Title - Sujet Centre des visiteurs Green Gables –	
Solicitation No. - N° de l'invitation ED001-171995/A	Amendment No. - N° modif. 003
Client Reference No. - N° de référence du client R.081199.001	Date 2017-01-03
GETS Reference No. - N° de référence de SEAG PW-\$PWC-024-4013	
File No. - N° de dossier PWC-6-39139 (024)	CCC No./N° CCC - FMS No./N° VME
Solicitation Closes - L'invitation prend fin at - à 02:00 PM on - le 2017-01-05	Time Zone Fuseau horaire Atlantic Standard Time AST
F.O.B. - F.A.B. Plant-Usine: <input type="checkbox"/> Destination: <input checked="" type="checkbox"/> Other-Autre: <input type="checkbox"/>	
Address Enquiries to: - Adresser toutes questions à: Bysterveldt, Crystal	Buyer Id - Id de l'acheteur pwc024
Telephone No. - N° de téléphone (902) 940-7122 ()	FAX No. - N° de FAX (902) 566-7514
Destination - of Goods, Services, and Construction: Destination - des biens, services et construction:

LE PRÉSENT ADDENDA VISE À PRÉSENTER LES RÉPONSES SUIVANTES AUX QUESTIONS POSÉES PAR LES SOUMISSIONNAIRES.

**GREEN GABLES-PHASE 1
BARN EXPANSION
AND RENOVATION**
QUEENS CO., PEI

**STRUCTURAL
PARTIAL LOFT FRAMING
PLAN AND SECTION**

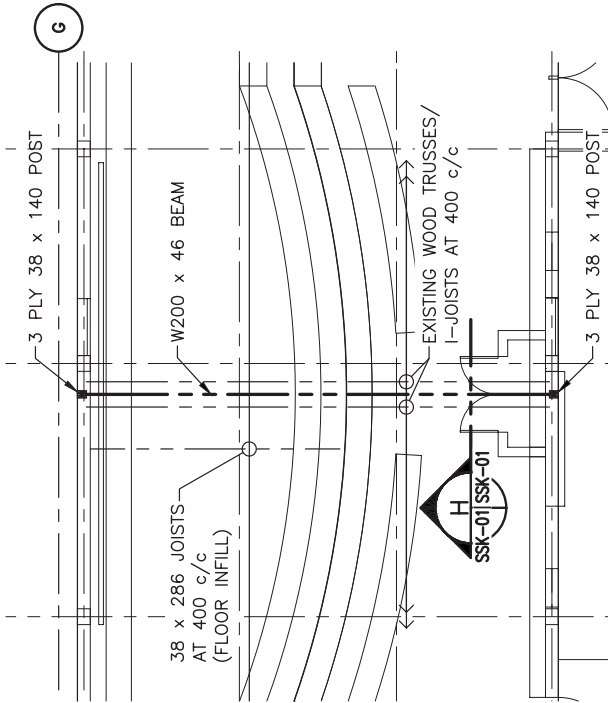
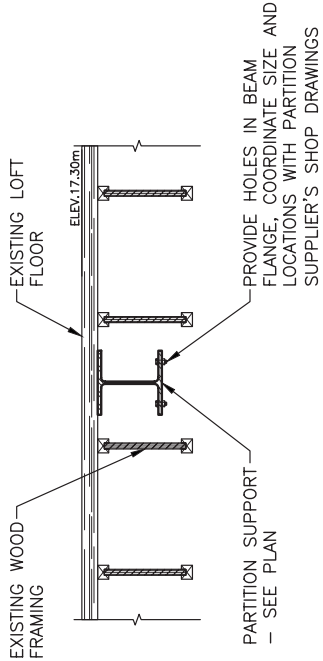
Question 5:

What is the beam requirement for the new folding partition in the multipurpose room D101?

Refer to attached sketch SSK-01.
